## Product Change Notification

### PCN-IFC-6581-2021

Business Unit	Product Line Code	Type of Change	Action	Date of Issue
IFC - Industrial Field Connectivity	BF2	Product Change Notification	Notify Distributors and Field	4/14/2021

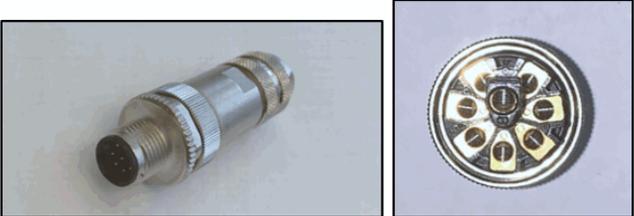
The 8-pos. M12 connectors with screw connection has been redesigned. The metal components have been swapped out for turned parts. The external dimensions remain unchanged. The shielded connectors have an updated cable gland. In the new concept, the cable seal and the clamping cage are combined in a single module making it easier to assemble. The external cable diameter range remains unchanged. The approvals, such as UL, will also remain unchanged.
